# UNITED STATES PATENT AND TRADEMARK OFFICE

APPLICATION NO.	FILING DATE	FIRST NAMED INVENTOR	ATTORNEY DOCKET NO.	CONFIRMATION NO.
10/723,200	11/26/2003	William P. Collins	C-2605	9042

**Office Action Summary**

The present application is directed to a fuel cell power plant wherein the disclosed inventive concept comprises the specific additional energy recovery device for receiving gas/liquids.

**[0013]** FIG. 1 is a simplified schematic diagram of a fuel cell power plant including a primary energy recovery device connected to a cell stack assembly and the combustion-supported reaction means of a fuel processing system in accordance with the prior art;

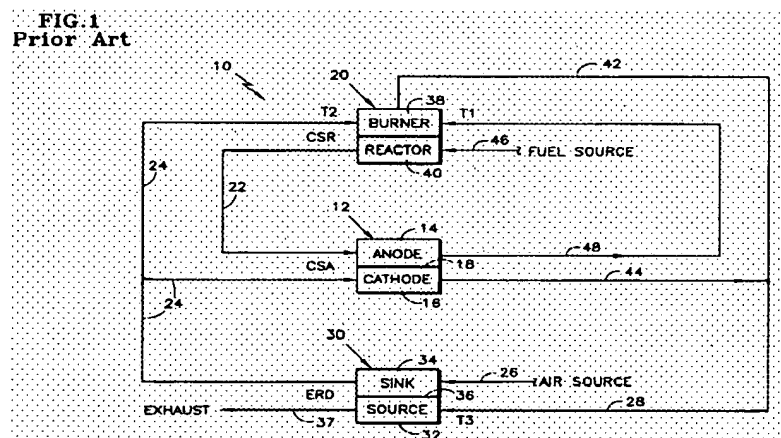
In particular, applicants in their Prior Art admission has admitted that **Figure 1** below illustrates most the fuel cell components and features claimed in claim 1 such as the fuel cell stack, the fuel cell processing system including the combustion supported reaction means; the anode/cathode flows and fluid distribution arrangement; and the primary energy recovery device; the combined cathode exhaust and the combustion-supported reaction means and related fluid connections. Essentially, **Figure 1** below does not include additional energy recovery device of the gas/liquid type (See Figures 1 and Figure 3).

The Prior Art discloses all the claimed limitations with the exception of the additional energy recovery device of the gas/liquid type; the upstream location of the primary ERD; and the specific combustion reaction means.

**Figure 1** below illustrates Grasso et al's fuel cell system including the enthalpy exchange barrier 12 in connection to oxidant supply 30.

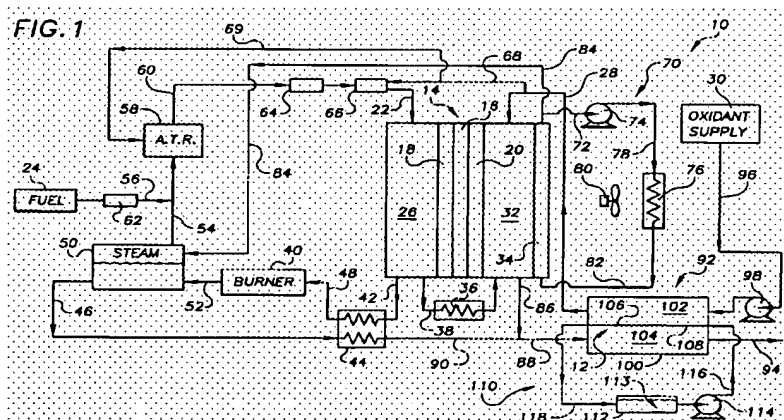
Grasso et al disclose a fine pore enthalpy exchange barrier (TITLE) for use with a fuel cell power plant and it includes a support matrix that defines pores and a liquid transfer medium that fills the pores creating a gas barrier (ABSTRACT/CLAIM 1). An inlet surface of the enthalpy exchange barrier is positioned in contact with a process oxidant inlet stream entering a fuel cell power plant (ABSTRACT/CLAIM 1), and an opposed exhaust surface of the barrier is positioned in contact with an exhaust stream exiting the plant so that water and heat exchange from the exhaust stream directly into the process oxidant inlet stream to heat and humidify the stream as it enters the plant (ABSTRACT/CLAIM 1). The liquid transfer medium may include water (ABSTRACT/CLAIM 1).

As evident from **Figure 2** above, the enthalpy exchange barrier is upstream of the fuel cell system (See Figure 2).
